RE: NICOLE'S AUTOMOTIVE SHOP (K11-D61). ENGINEER"S CERTIFICATION FOR CERTIFICATE OF OCCUPANCY APPROVAL. ENGINEER'S STAMP DATED AUGUST 29, 2000.

RE: NICOLE'S AUTOMOTIVE SHOP (K11-D61). GRADING AND DRAINAGE PLAN FOR BUILDING PERMIT APPROVAL. ENGINEER'S STAMP DATED JULY 23,

TRAFFIC CIRCULATION LAYOUT REVIEW FOR BUILDING PERMIT

NICOLE'S AUTOMOTIVE SHOP, K11-D061, Architect's Stamp dated 7-23-99

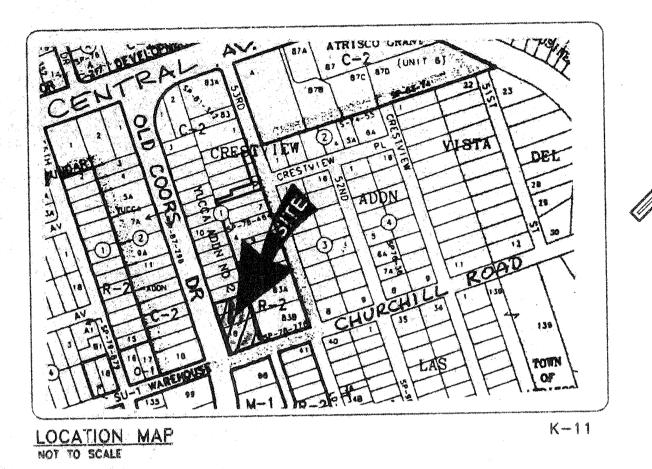
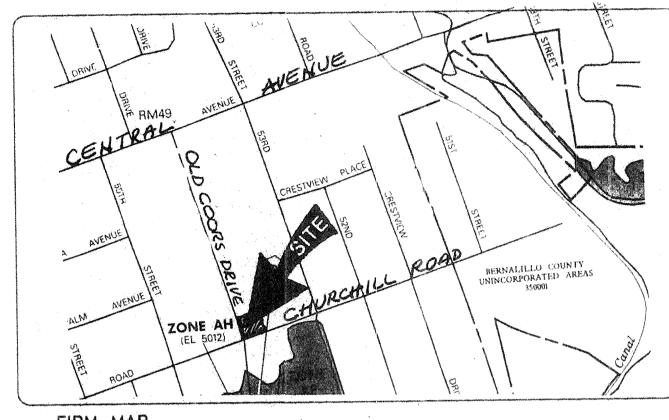
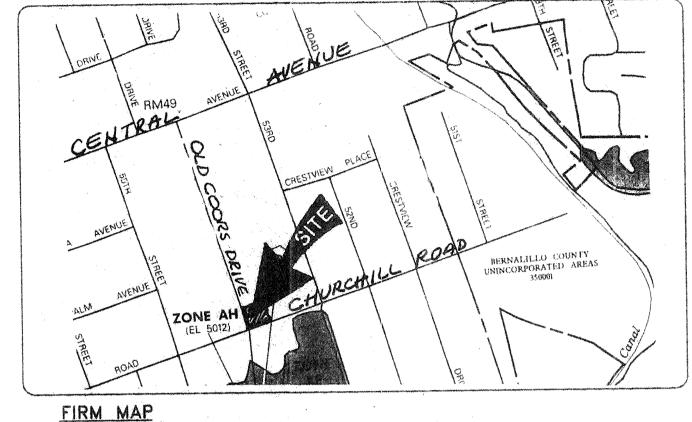
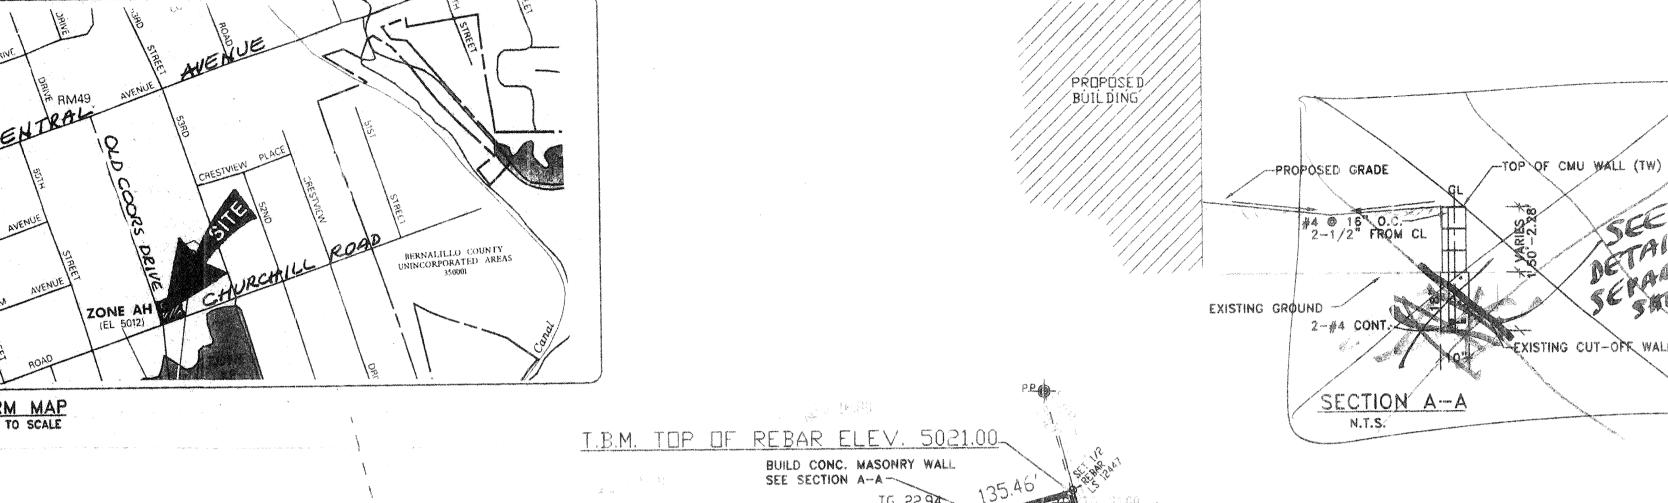
The above referenced Traffic Circulation Layout (TCL) requires modifications to the site plan prior to review for Building Permit.

The comments are indicated in red ink on the attached marked-up site plan.

- Clearly indicate what the gravel area on the north side of the site is for; need curbing at the edge of the asphalt area.
- Need building and pedestrian protection along the building, (i.e. bollards).
- The main entrance to the building is not shown.
- Are all three driveways built with the City Public Works project?
- Need dimensions for parking stalls.
- The exact location of the gates should be indicated.
